Appendix F. Product Equality Declaration

ZTE CORPORATION**Product Change Description**

[ZTE N9500]
[ZTE Corporation]
[Project Number:12ZTE132]
FCC ID: Q78-ZTEN9500

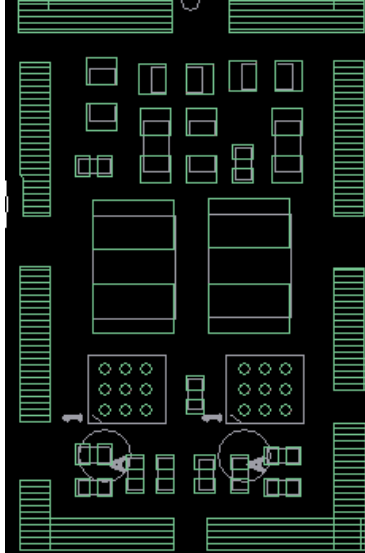
B: Delete redundant components:

S4200, C4221, C4220, L4215, L4210, L4216, L4208, L5121, L5120, L5119, C5121, C5122, S5100, C5118.

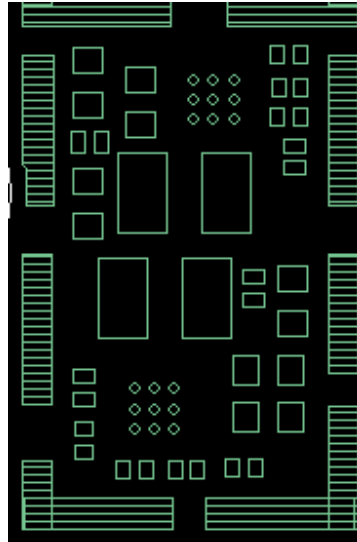
D: Optimize ADP components layout.

Please notice that only change components layout but PCB layout is same.

Original:

Now:
